ADDENDUM

NO. 3

PROJECT NAME: Humble ISD Creekwood and Riverwood Middle School Additions and Renovations

ADDENDUM DATE: Tuesday, April 29th, 2025

ELECTRICAL POWER FLOOR
PLAN - SECTION B

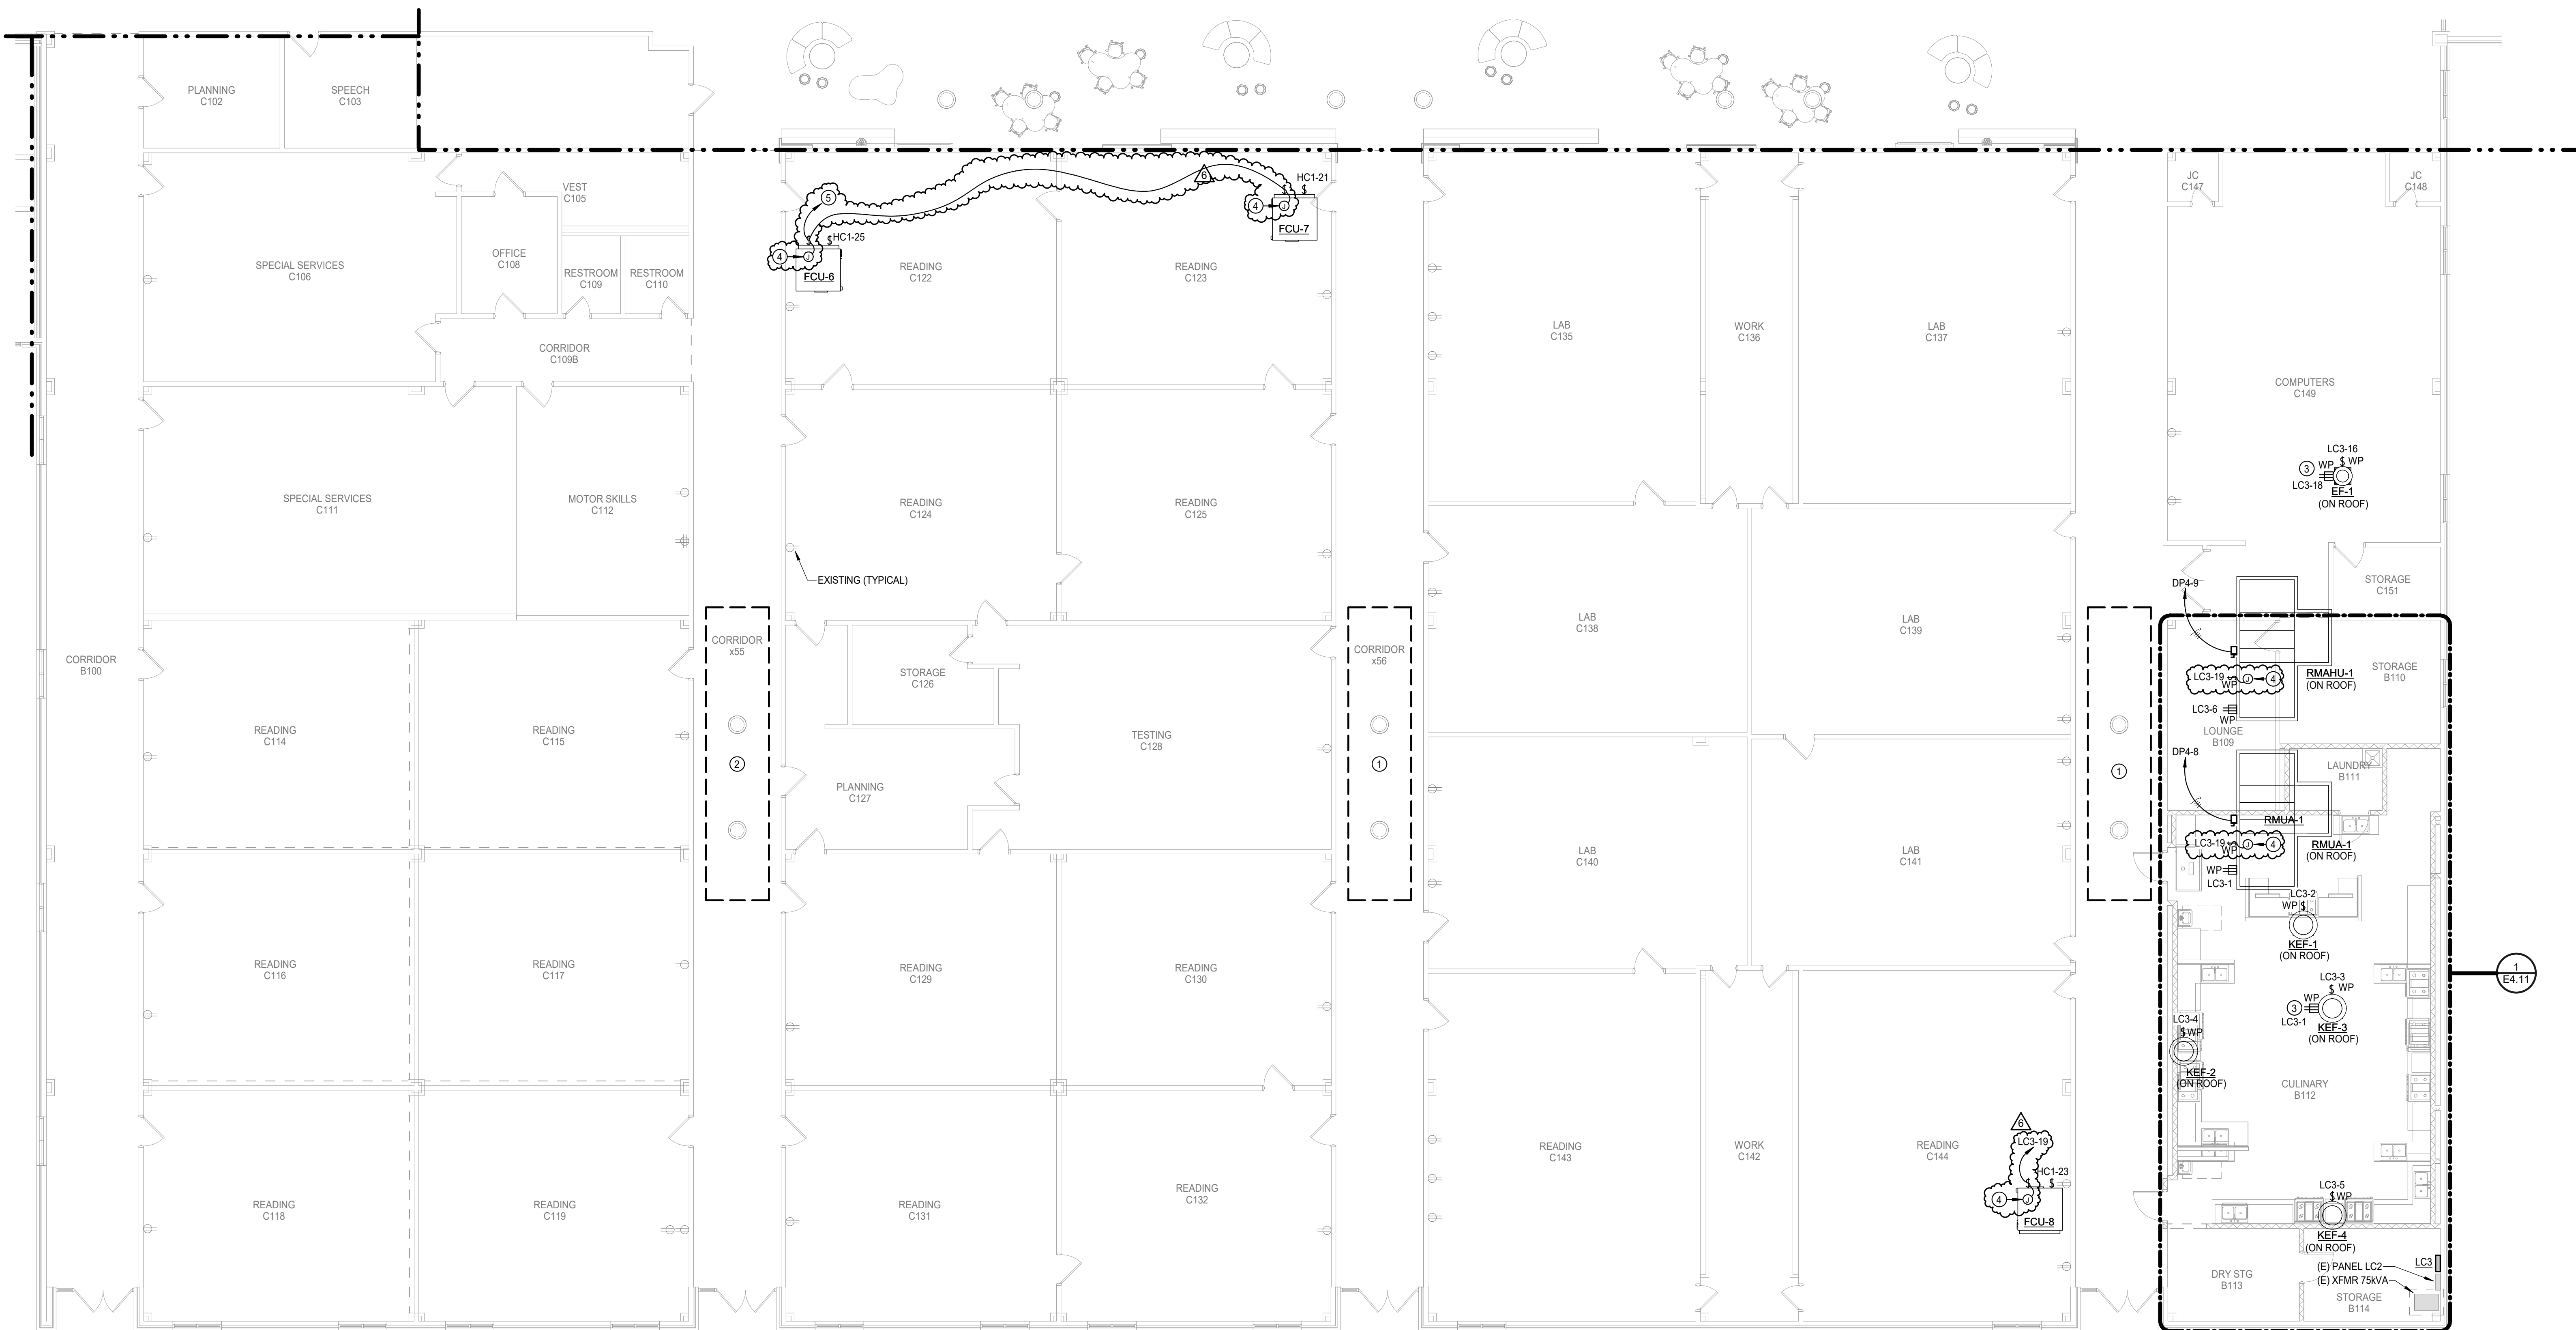
3. E3.12 – ELECTRICAL POWER FLOOR PLAN – SECTION B
 - a. Add 120v branch circuitry to RMAHU-1, RMUA-1, FCU-6, FCU-7, FCU-8 for air purification.
 - b. Add keyed notes 4 and 5.

ELECTRICAL POWER FLOOR
PLAN - SECTION C

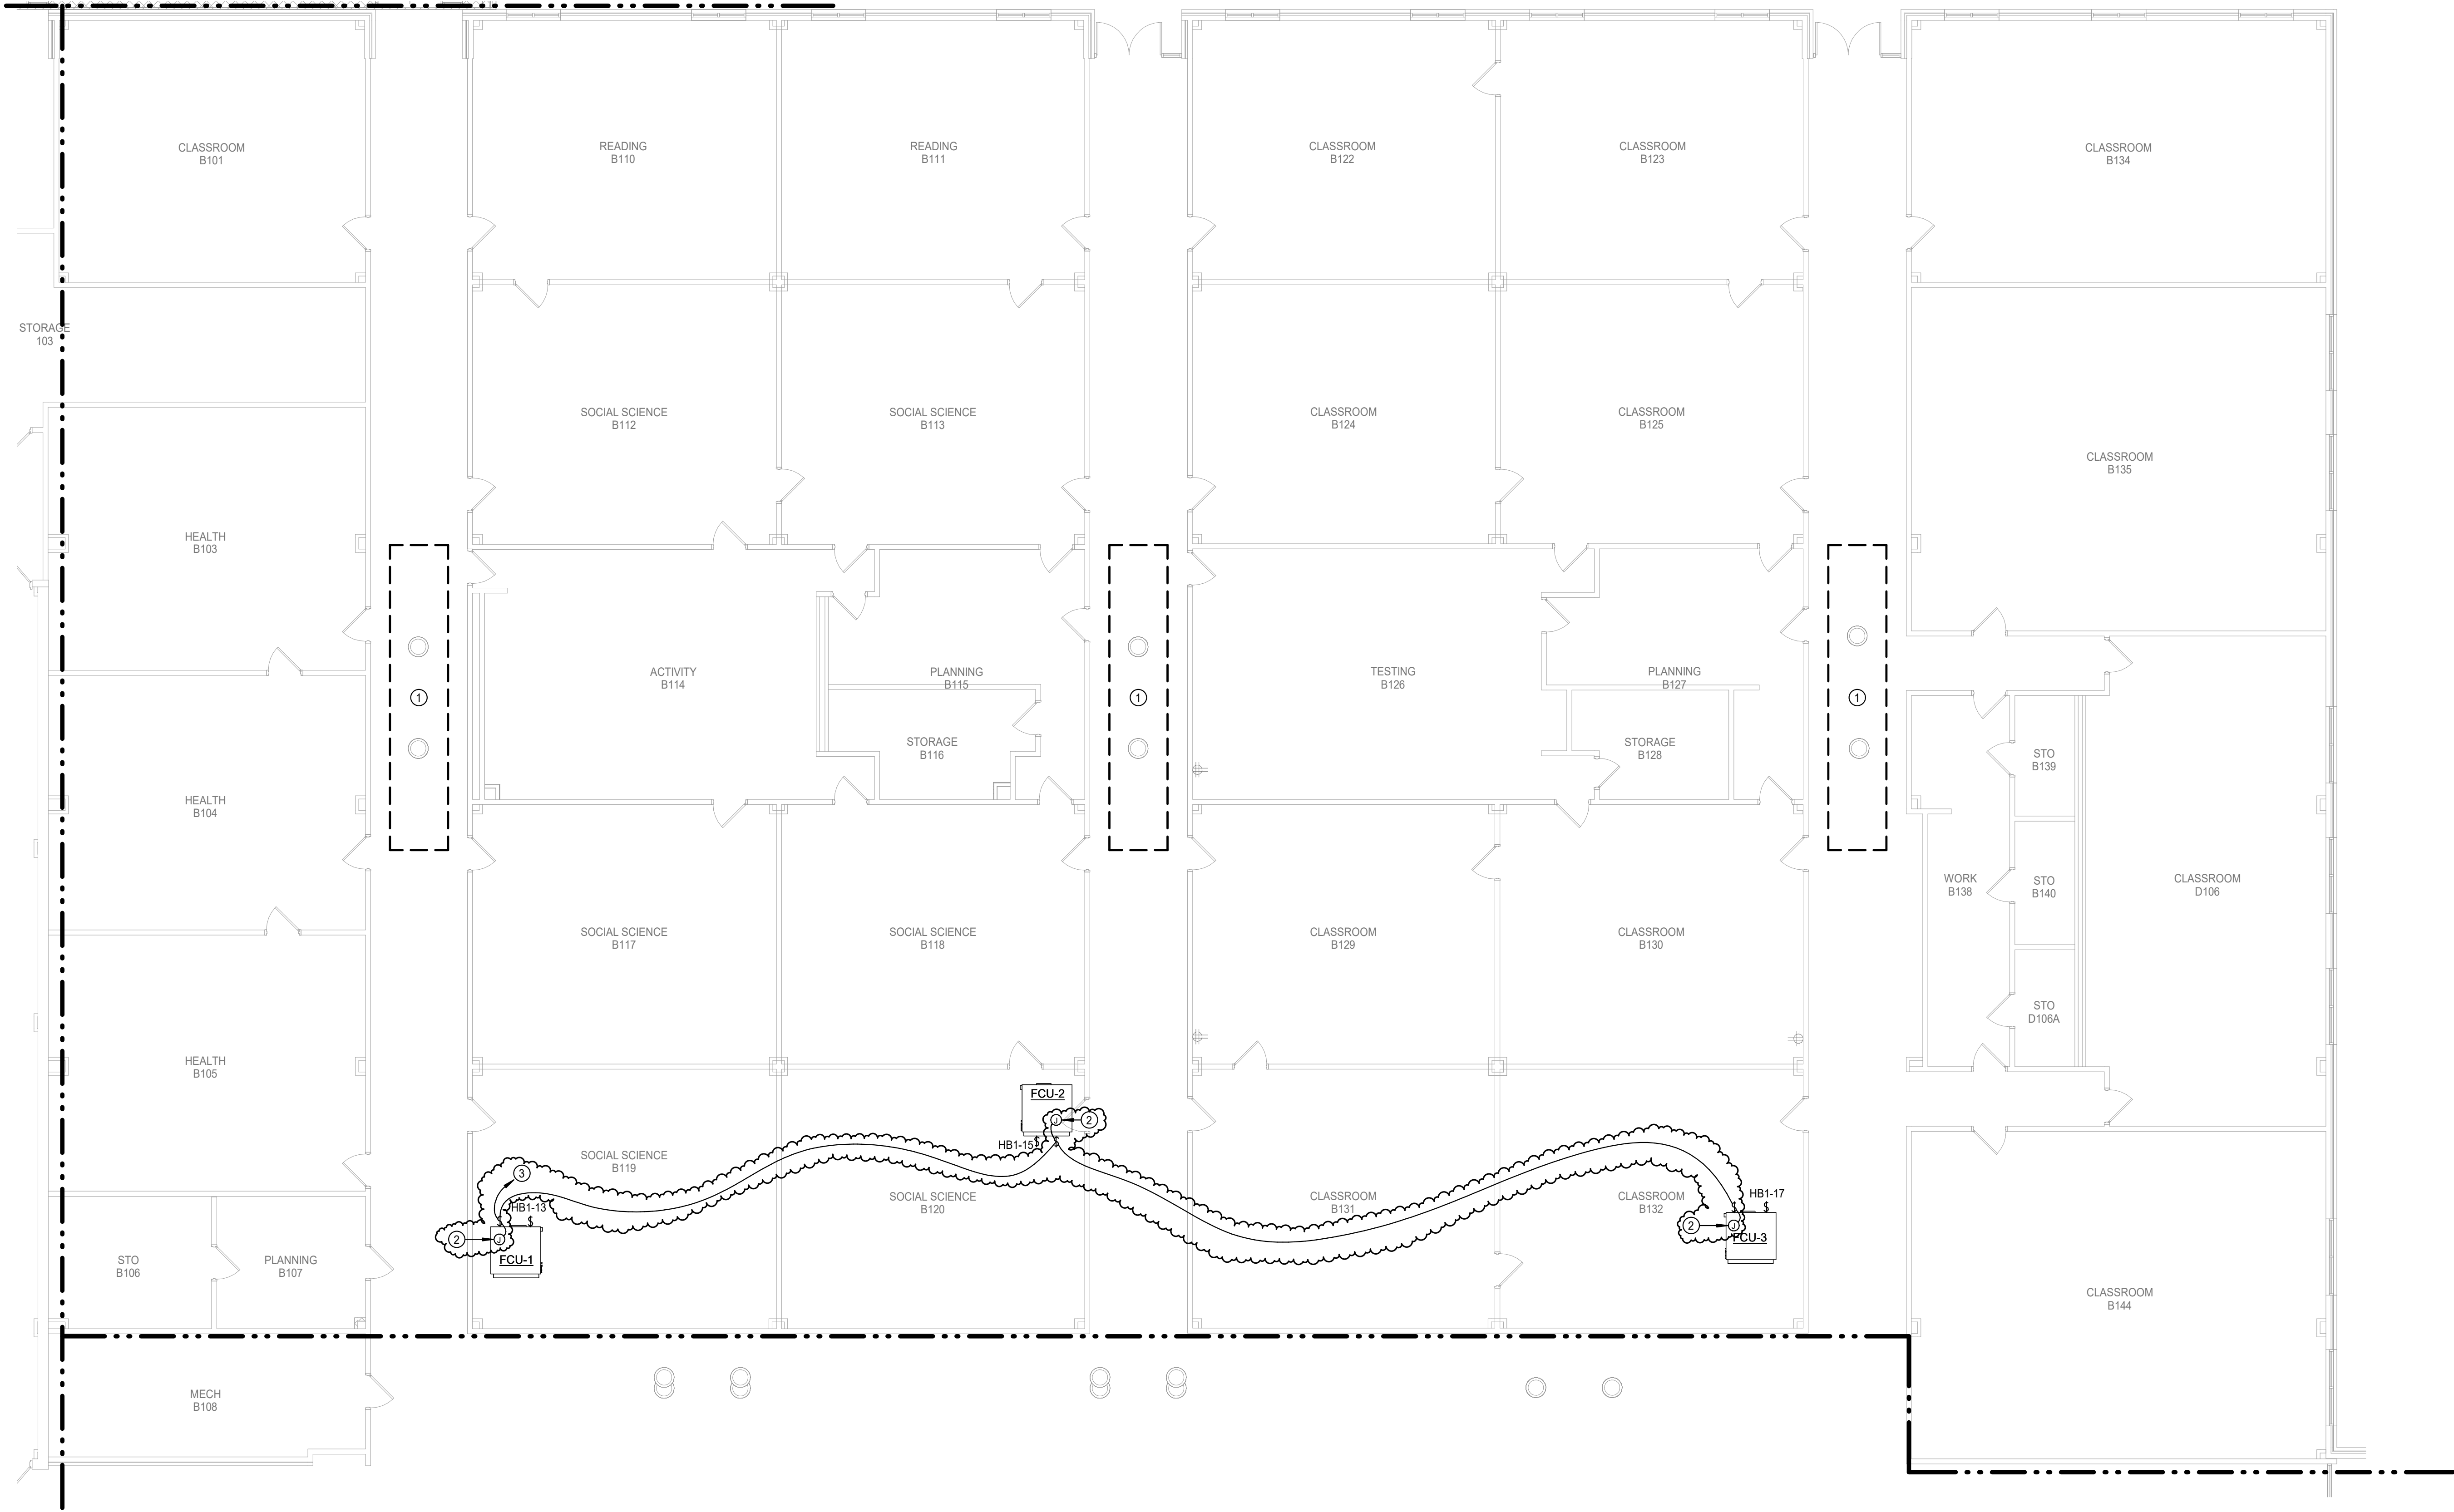
- c. Replace sheet in its entirety.
4. E3.13 – ELECTRICAL POWER FLOOR PLAN – SECTION C
 - a. Add 120v branch circuitry to FCU-5 for air purification.
 - b. Add keyed notes 6 and 7.

PACKAGE: Job No. 1821-13-02
VOLUME: Sheet No. **E3.11**
Drawn By: DES
Date: 04/01/2025

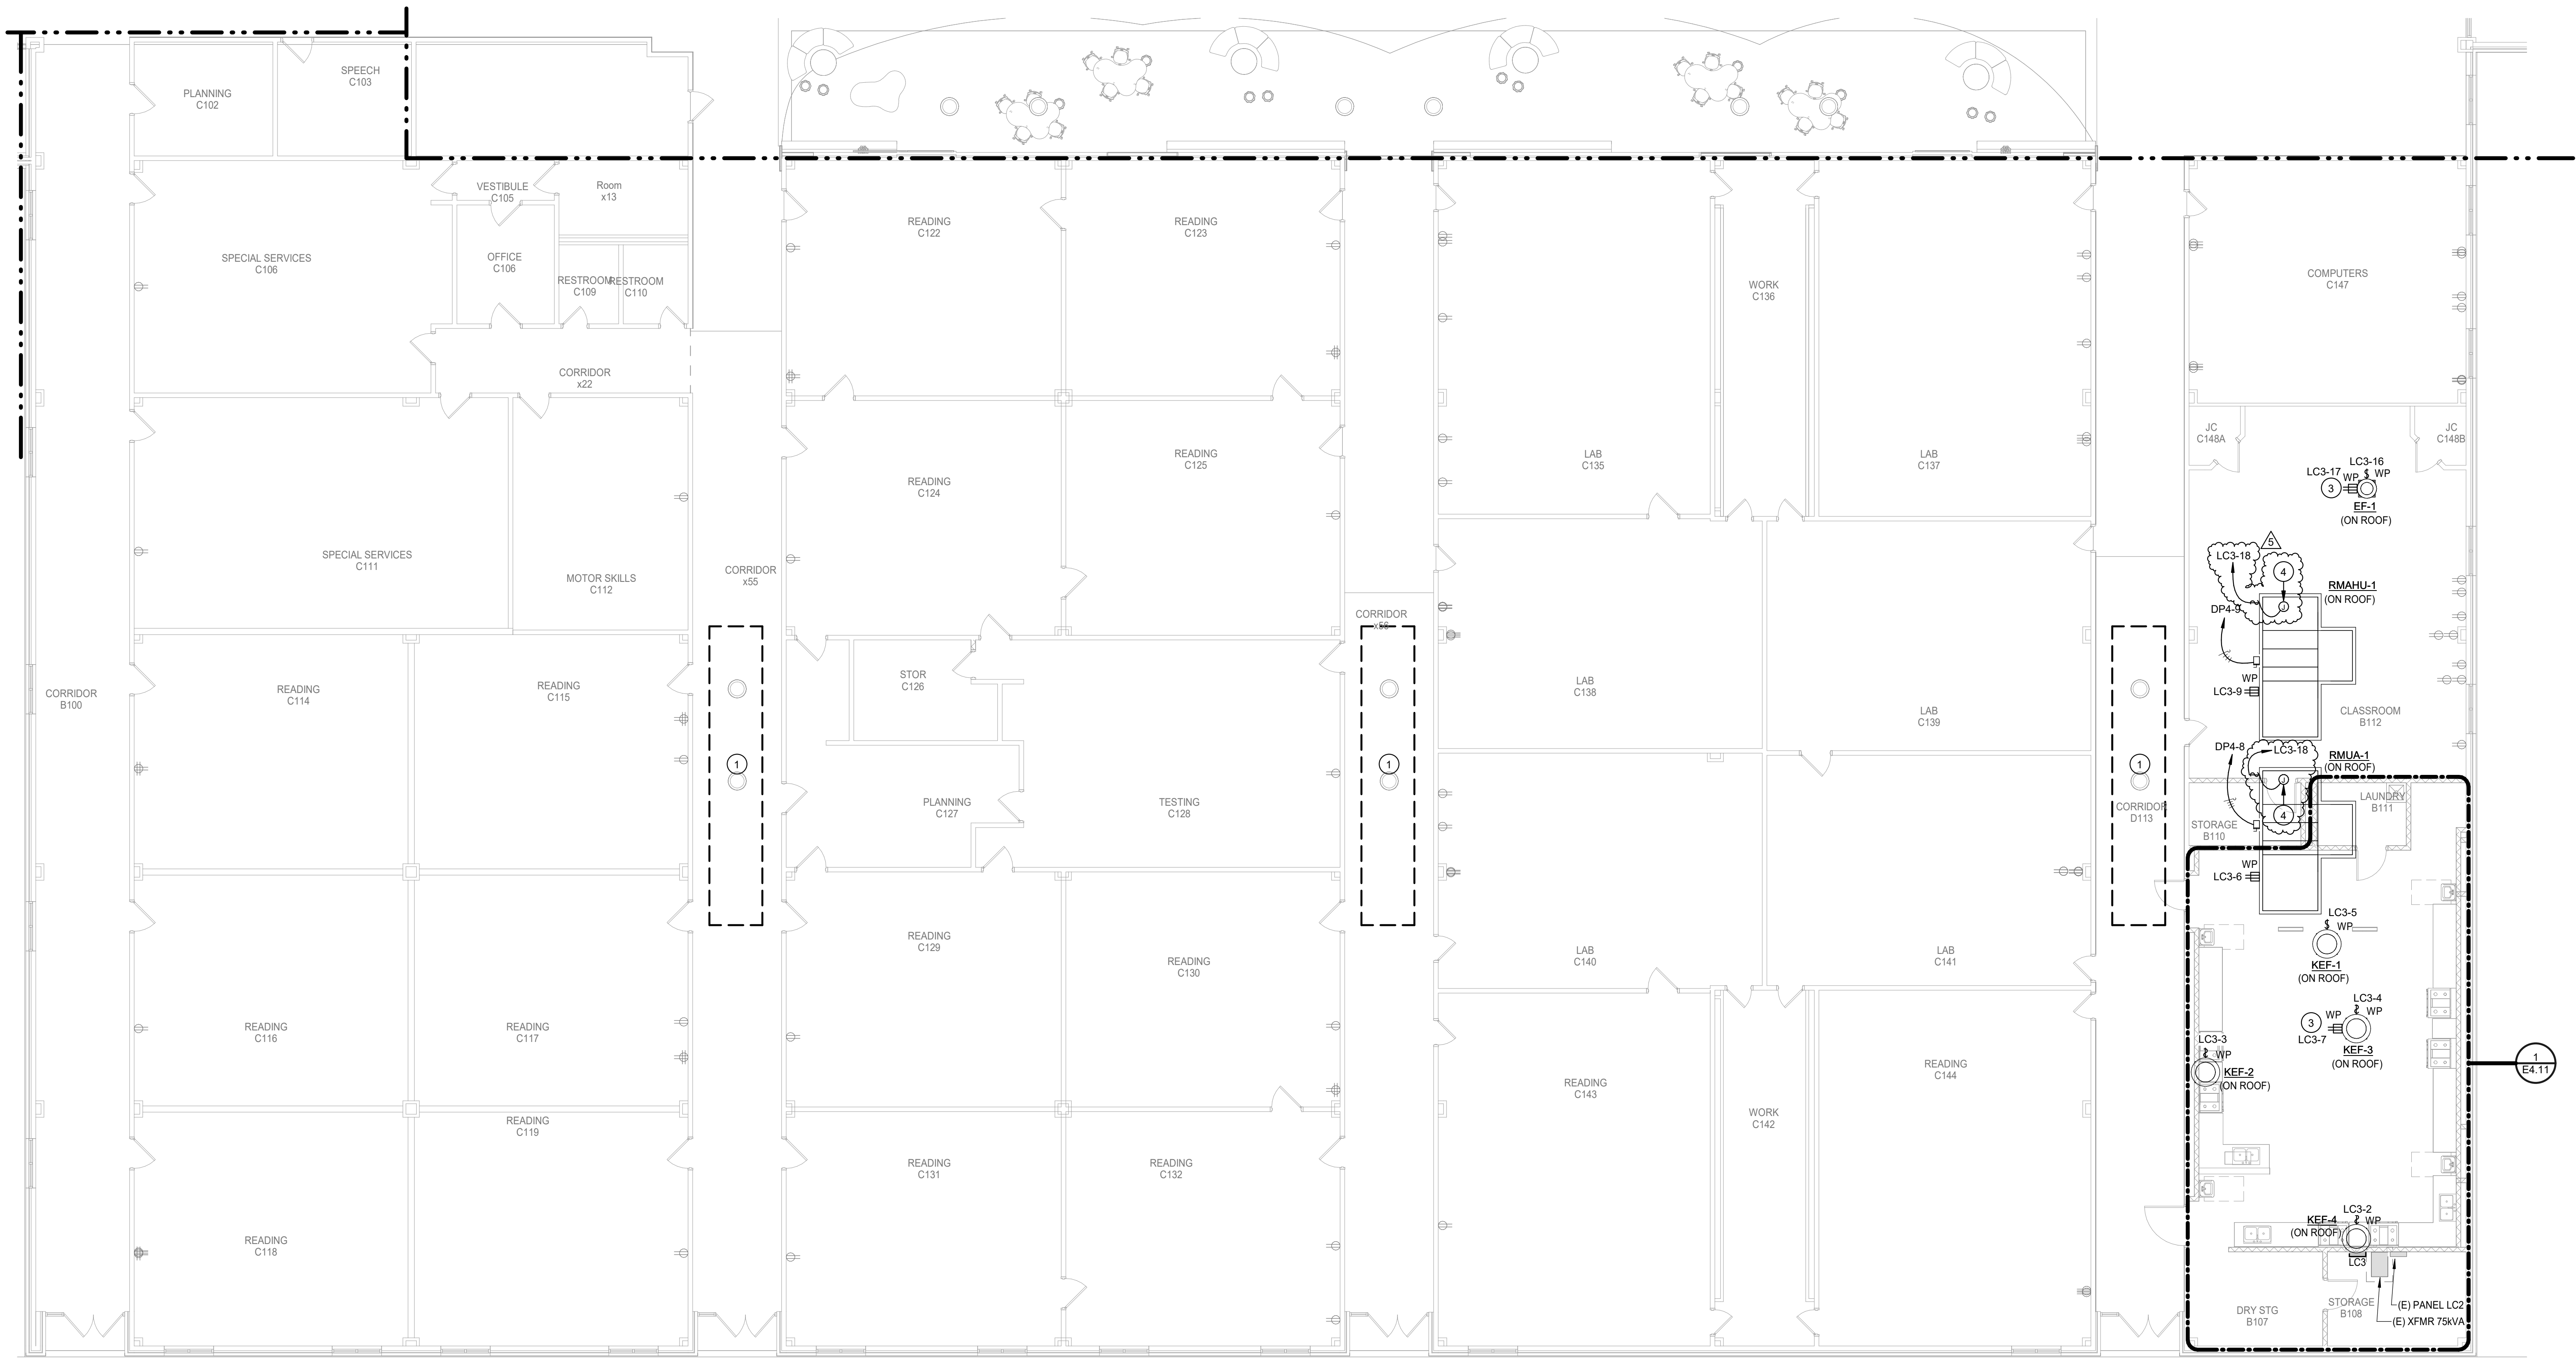
- a. Revise air handling unit schedule.
 - b. Replace sheet in its entirety.
- 2. E3.11 – ELECTRICAL POWER FLOOR PLAN – SECTION A
 - a. Add circuit LE-16 to AHU-3 for air purification.
 - b. Replace sheet in its entirety.
- 3. E3.12 – ELECTRICAL POWER FLOOR PLAN – SECTION B
 - a. Add 120v branch circuitry to RMAHU-1, RMUA-1 for air purification.
 - b. Replace sheet in its entirety.
- 4. E6.11 – ELECTRICAL PANEL SCHEDULES
 - a. Panel LC3, add branch circuit 18.
